RESPONSES TO NRC  
COMMENTS ON THE  
MOAB FAULT, UTAH

26 May 1994

Subject: **Responses to NRC Comments on the Moab Fault, Utah**

**RESPONSE TO NRC COMMENTS ON THE MOAB FAULT**

Source: Doelling, 1985		Project No. SK9407		Moab Uranium Mill Tailings Site		R 21 E R 22 E	
		Woodward-Clyde Federal Services				Figure 1

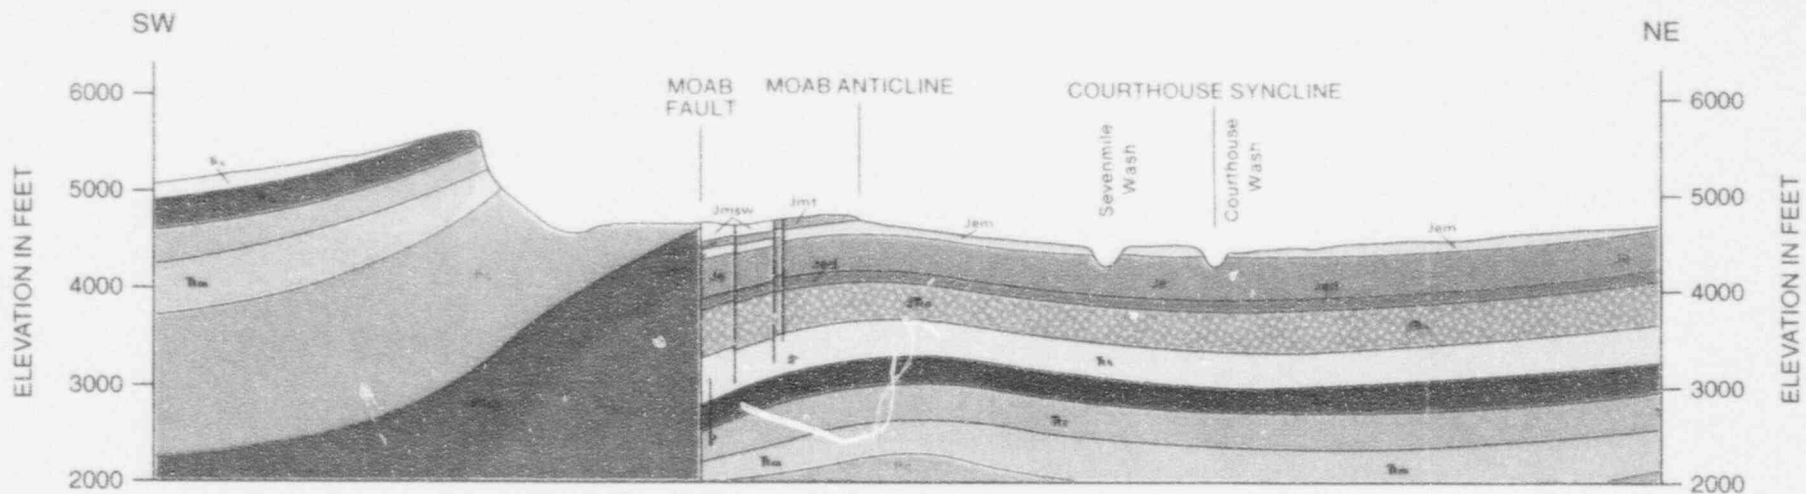
ISSUE 1: "There is evidence that a fault runs under the disposal site. Evaluate the extent of faulting under the disposal site and determine if there is capability for surface rupture."

On the geologic map of the Arches National Park and vicinity, Doelling (1985) of the Utah Geological Survey (UGS) shows a concealed section of a northwest-striking, northeast-dipping normal fault, which extends from a point 1.6 km northwest of the Atlas tailings pile to the southwest for a distance of 5 km (Figure 1). He suggests this fault is one of two traces of the Moab fault and that it extends beneath the tailings pile. Doelling (1985) also shows the other parallel trace of the Moab fault concealed, located a few hundred meters to the southwest, and not traversing the tailings pile. In cross-section, Doelling (1985) portrays the Moab fault as juxtaposing, in the near-surface, Pennsylvanian rocks (principally salt of the Paradox Formation) capped by Permian Cutler Formation on the west against Jurassic and Triassic rocks such as the Entrada and Morrison sandstone on the east (Figure 2). The fault exhibits a total displacement of about 790 m near the Colorado River (Yeats, 1961).

The closest exposure of the Moab fault, 1.6 km northwest of the tailings pile, occurs in the Entrada sandstone. No direct evidence for southeastward continuation of the fault exists in

the Quaternary alluvial deposits that apparently bury the fault along the west side of the northern Moab Valley and at the tailings pile (Figure 1). The Moab fault is observed, however, along strike in bedrock 6 km southeast of the tailings pile and about 2 km south of Moab (Doelling, 1993). Doelling (1985) apparently extended the fault to the southeast beneath the tailings pile assuming the Moab fault is continuous through this area and connects the two bedrock faults observed to the north and south. This interpretation need not be the case, as the exact location of any faults is concealed beneath Quaternary sediments. Elsewhere, a complex geometry with multiple strands and steps is observed along the Moab fault and this is also probably the case along this concealed section. Thus, no definitive evidence exists for a fault located beneath the tailings pile. However, a buried fault or deformation zone may exist somewhere in this location, although its absence in Quaternary deposits suggests that it does not pose a surface faulting hazard to the site based on NRC criteria for a "capable" fault (see following discussion).

Less than 1 km to the north of the tailings pile, a series of relatively short northwest-striking faults, dipping both northeast and southwest, apparently offset Navajo sandstone of Triassic/Jurassic age. Doelling (1985) did not extend these faults to the southeast into the Quaternary alluvium in Moab Valley (Figure 1). These faults probably represent tensional features over the crest of the Moab anticline which have undergone displacement due to dissolution of the underlying salt of the Paradox Formation (Doelling, 1985).

Project No. SK9407	Moab Uranium Mill Tailings Site	GEOLOGIC CROSS-SECTION THROUGH THE MOAB FAULT	Figure 2
Woodward-Clyde Federal Services

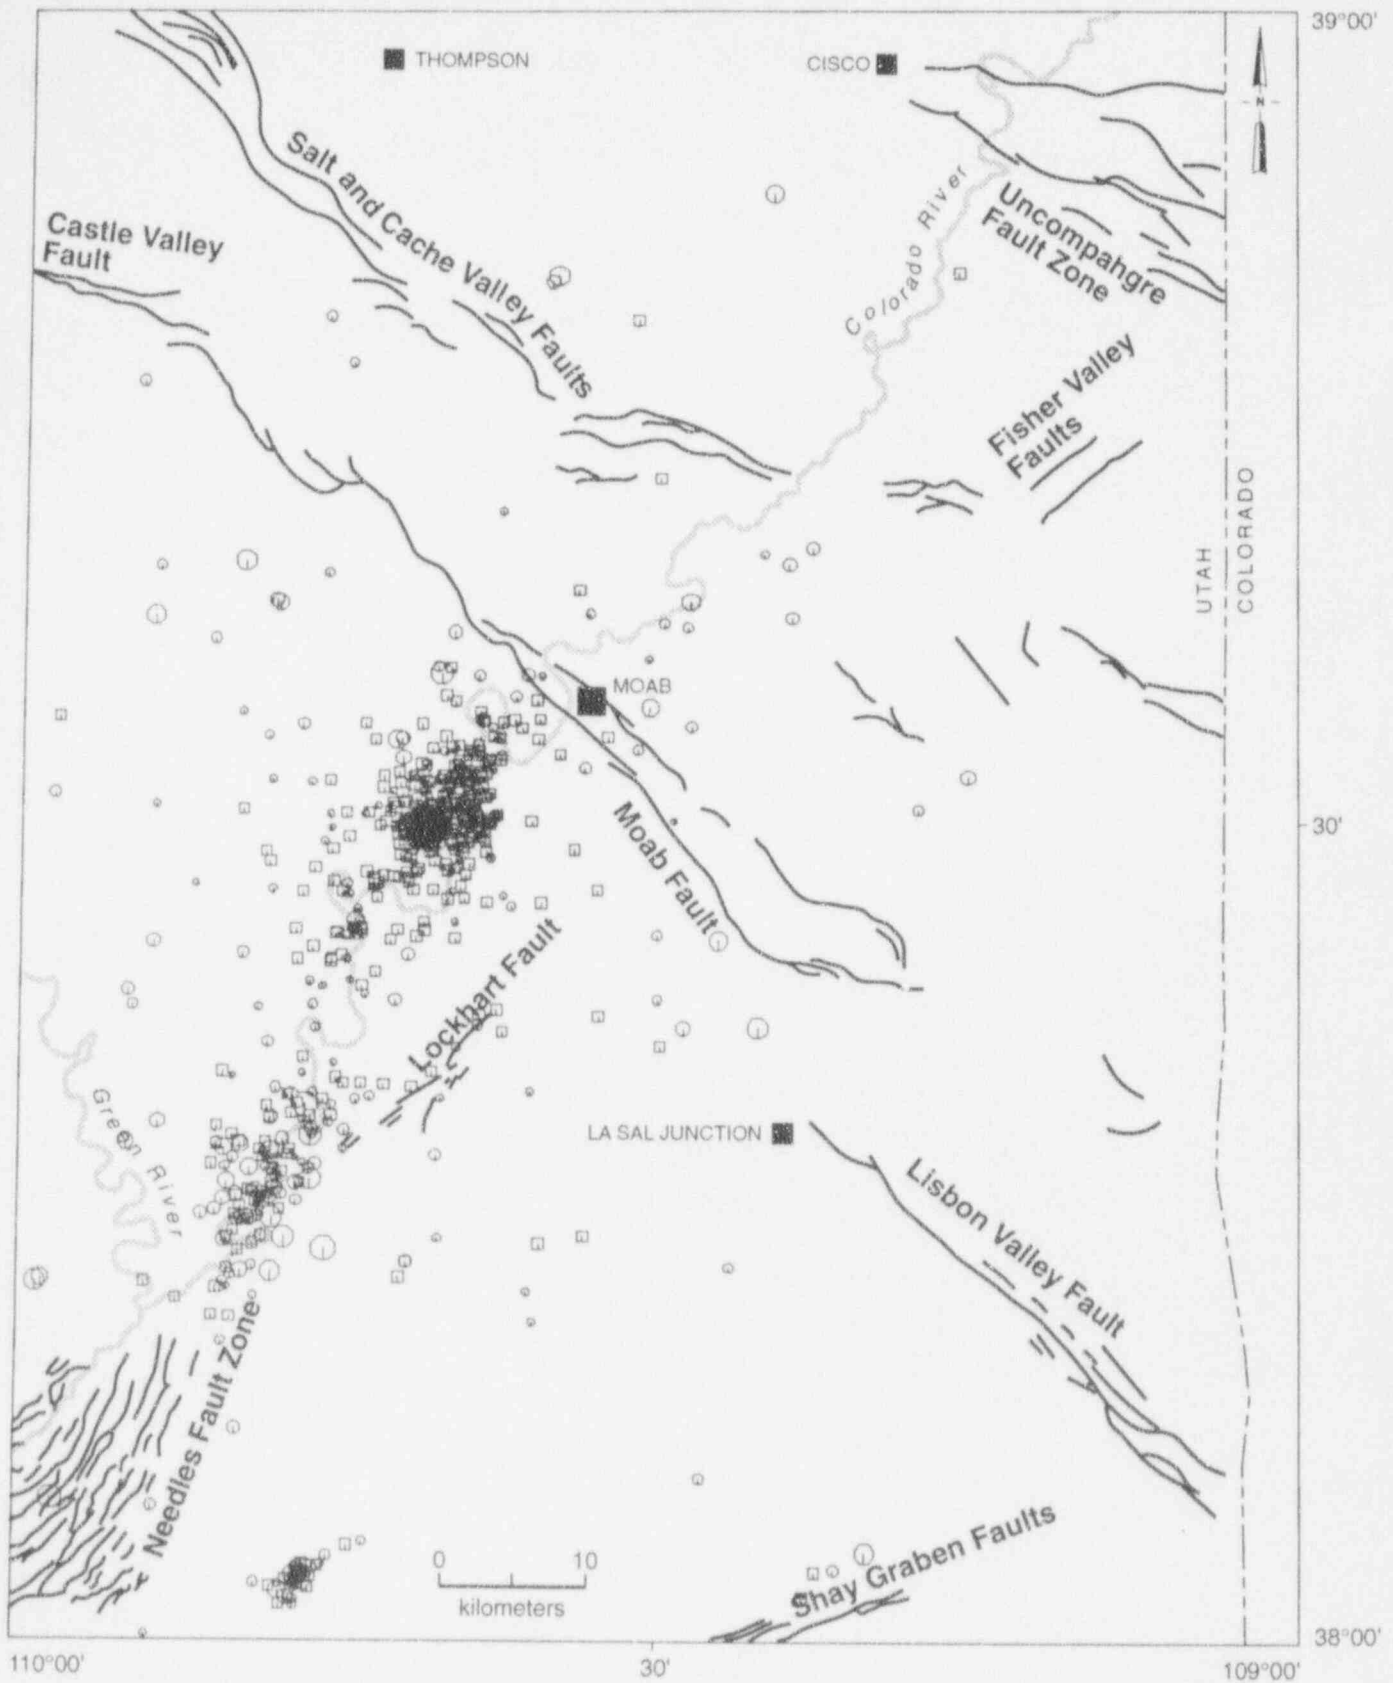
ISSUE 2: "Evaluate the seismic potential for faults adjacent to the site, including the potential for fault movement due to salt dissolution."

Recent discussions with UGS staff about their unpublished mapping indicate their findings are consistent with our interpretations of the Moab fault. Earlier studies suggested that the Moab fault may extend below the salt, offsetting pre-Paradox Formation strata (Shoemaker et al., 1958). In contrast, we interpret the Moab fault as a structure which developed primarily from salt dissolution and migration although movement along the fault has also

probably been in partial response to broad regional tectonic stresses (Woodward-Clyde Consultants, 1982; 1984). We also believe the fault is confined to the Paradox Formation and overlying strata. Based on borehole data, Hite (1978) suggested that the analogous Lisbon Valley fault to the southeast does not penetrate through the salt (Figure 3). Pre-Paradox faults may exist beneath the salt (Figure 3), but no evidence exists that these faults are continuous with faults, such as the Moab fault, observed at the surface.

Recent studies by the UGS also suggest the Moab fault does not penetrate beneath the salt based on seismic data (M. Ross, UGS, personal communication, 1994). According to Ross, a seismic profile near the visitors center at Arches National Park shows the Moab fault becoming listric near the top of the Paradox Formation at a depth of about 914 m (3,000 ft) where it soles out within the salt. Other seismic profiles to the north along the Moab fault also show the fault dying out within the Paradox Formation (M. Ross, UGS, personal communication, 1994).
